TECHNICAL SERVICE BULLETIN

TECHNICAL SERVICE BULLETIN: 10-1871
SERVICE CAMPAIGN: 001169
EXPIRATION DATE: 12/1/2025

Forest River is alerting you to an issue involving certain 2025 Rockwood RLT2606WS and Flagstaff FLT26RBWS Travel Trailer Recreational Vehicles. Please see the information below, which describes the issue and provides you with details on the steps you should take to have your vehicle repaired.

TECHNICAL SERVICE BULLETIN 10-1871 REMEDY INSTRUCTIONS

Task Instructions:

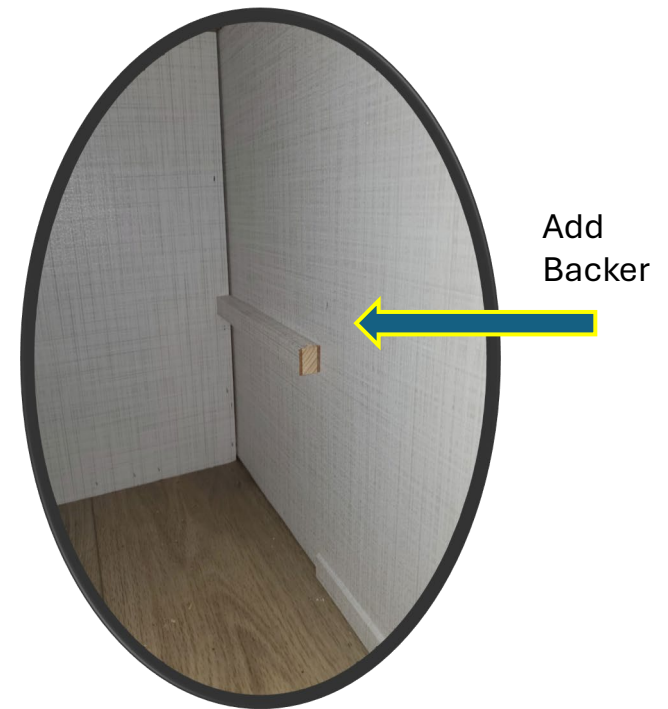
1. Inspect the unit in question to determine if there is a rail installed between the furnace and the water heater.
2. If a rail is not present, install a 20-inch rail between the furnace and the water heater as indicated in the provided reference (see attached image).
3. Ensure the rail is mounted at the same height as the existing rail on the unit.
4. Secure the rail using 1-inch black screws.
